Office Action Summary	Application No. 10/666,855	Applicant(s) WADA ET AL.	
	Examiner SEOKYUN MOON	Art Unit 2629

- 1) ☒ Responsive to communication(s) filed on 04 January 2008.
- 2a) ☒ This action is **FINAL**. 2b) ☐ This action is non-final.
- 3) ☐ Since this application is in condition for allowance except for formal matters, prosecution as to the merits is closed in accordance with the practice under *Ex parte Quayle*, 1935 C.D. 11, 453 O.G. 213.

DETAILED ACTION

Drawing 1

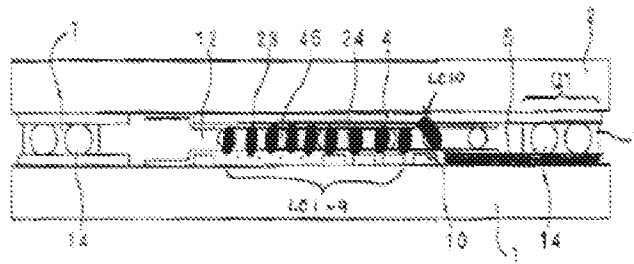
The Applicant [Applicant's Remark: page 8 3rd paragraph] pointed out that the prior art of record (US 6,806,938, herein after "*Asakura*") does not teach "*the display area including intersecting sections*" (which is disclosed in 2nd paragraph last line of claim 1, as "*intersecting sections in the display area*"). Specifically, the Applicant argued that it is not proper to refer area 4 [drawing 1 provided below, which is equivalent to fig. 2 of *Asakura*] as a display area since *Asakura* defines area 3 as a display area and the area located between area 3 and the sealing material 7 is considered as a dummy area.

Examiner respectfully disagrees.

Examiner might agree with the Applicant that it is common and well known in the art to refer an area dedicated to display images, as a display area [Applicant's Remark: page 8 4th paragraph]. However, the Examiner respectfully submits that the Examiner's interpretation, i.e. referring area 4 as a display area instead of referring area 3 as a display area, is consistent with the Applicant's view or interpretation regarding the claimed display area. As well known in the art and acknowledged by the Applicant, pixels used to display images are located at intersections of a plurality of first electrodes and a plurality of second electrodes [Applicant's specification: par. (0009) lines 3-6]. In other words, an image cannot be

formed or displayed on an area where there is no first electrode and second electrode. Therefore, if the Applicant's assertion, i.e. referring only the area that contributes to image display and is exposed to users, as a display area, is applied to the instant invention, it would not be reasonable to indicate the intersecting section to be included in the display area since the intersecting area does not include any second electrode, and thus an image cannot be formed or displayed on that area. Furthermore, paragraph [0015] of the instant invention discloses introducing a light-block layer to prevent lighting-up at the intersecting area or the cross sections (which indicates that the intersecting area is not used as a part of a display area).

Accordingly, the Examiner respectfully submits that the Examiner's interpretation regarding the term, "*display area*" might not be obvious to one of ordinary skill in the art, but it is consistent with the Applicant's view or interpretation regarding the claim language, and thus it is reasonable for the Examiner to make such an interpretation.
